date : February 6, 1998
 author: Steve Hamilton
 company: Innovative Semiconductors, Inc.

PHY Timing Issues

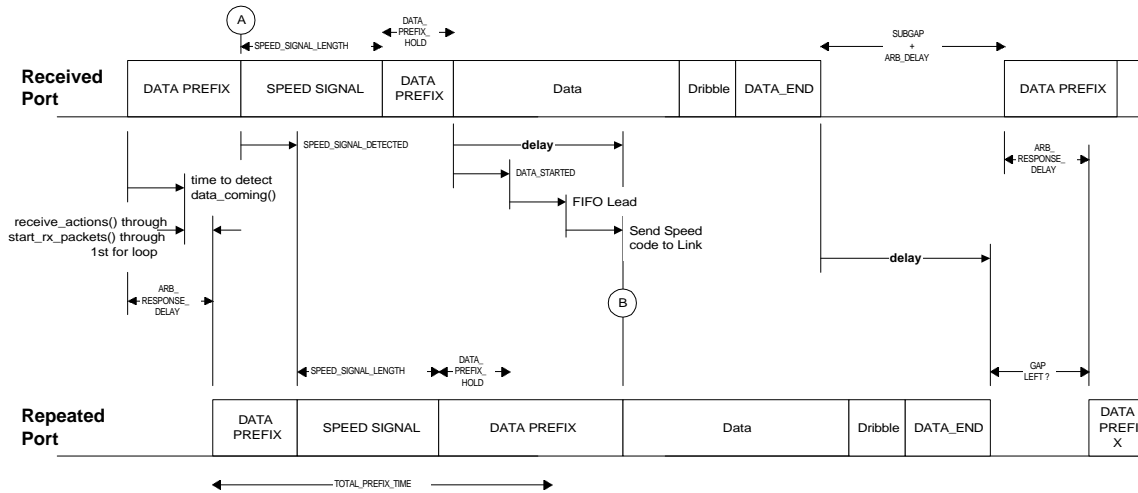
The first issue relates to which critical path determines point B in the above drawing. Point B is determined by the latest of 3 points. I believe the operating assumption of the specs to date has been that B is determined by the starting of data arrival. First transitions are detected, then enough of them have been counted to give the Resync buffer a sufficient lead (in case of clock tolerance issues), and finally moving the PHY-LINK interface from DATA_COMING to RECEIVE takes some time. These cumulatively are indicated by “delay” in the drawing. I believe this is what the standard’s PHY_DELAY refers to, although a precise reading leaves question as to whether the PHY_LINK action is included (i’ll assume it is).

Two other paths might determine B however. Starting from point A, some time is needed to recognize the presence of a speed signal (when there is one). The 1394A spec provides some good incites about how to do this, and why it may require some time. Then, once the speed signal is sent on the repeated port(s), data cannot be sent until SPEED_SIGNAL_LENGTH plus DATA_PREFIX_HOLD times elapse. These same 2 intervals (at a minimum) separate point A from the arrival of data on the receiving port. Therefore it is the difference between “delay” and SPEED_SIGNAL_DETECTED which determines if this, or the data arrival, will determine point B. If SPEED_SIGNAL_DETECTED is greater than “delay”, then the path from point A dictates B. The 1394A spec requires PHY_DELAY to be greater than 60 ns. No spec is given for SPEED_SIGNAL_DETECTED. But clause 7.10.1 and table 7-19 show how it might easily take 3 or more 50 MHz clocks (> 60 ns).

So who cares which of those paths determines B? Well what happens to data if speed signalling delays its transmission on the repeated port? It accumulates in the Resync buffer. If the resync buffer is too full at the start of the packet, and clock tolerance works against you, it can overflow before packet end. Oops!

A third path may determine point B. The portion of data prefix which is prior to speed signalling is a different length on the receiving port and the repeating port. The length on the repeating port is reduced by ARB_RESPONSE_DELAY time, and increased by SPEED_SIGNAL_DETECTED time. If this turns out to be a net reduction, then TOTAL_PREFIX_TIME may determine point B. This is probably not likely, and in any case its impact is identical to the previous case.

No matter which path determines point B, once it is determined, a delay between the incoming and repeating port is established. To keep things simple lets count this delay in base clocks, rather than time so we don't have to worry about clock tolerance between nodes. Since the data, dribble bits, and data end intervals will have the same number of clocks on both ports, this delay will also characterize the relationship between the start of the IDLE periods on both ports. On the receiving port the start of the next packet can occur only after a minimum gap of SUBACTION_GAP plus ARB_DELAY. When it occurs, it will be reflected on the repeating ports after ARB_RESPONSE_DELAY. Therefore, the gap length actually seen on the repeating port, which we wish to always exceed a SubActionGap produces the following equation which is then reduced.
